SERVICE BULLETIN

BULLETIN: 0029

OEM: John Deere

SUBJECT: JRB® Excavator Hydraulic Kit Swivels

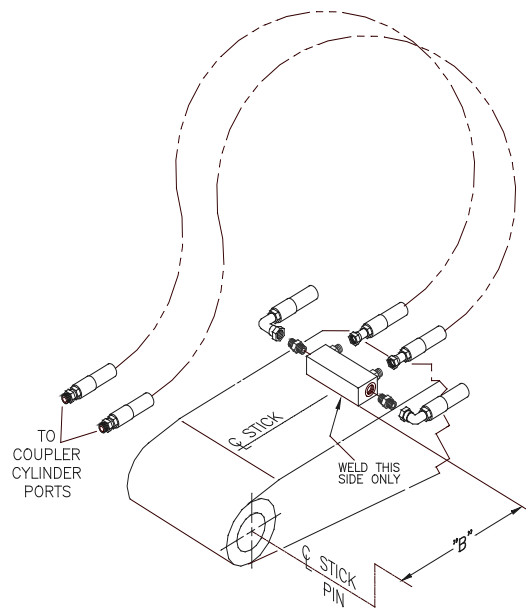
Due to the increased hydraulic pressures of the John Deere CLC excavators, JRB® has designed a modification for the coupler hydraulic kits for these machines. The issues regarding the higher pressures include swivels leaking and “locking up” or “freezing up”. A Manifold Conversion Kit has been developed to correct this problem. If you have a problem with swivels on a customers machine, call JRB® Customer Service at **1-800-428-2538**.

The manifold conversion kit is shipped complete with instructions for installation. The labor for installation is typically less than two hours.
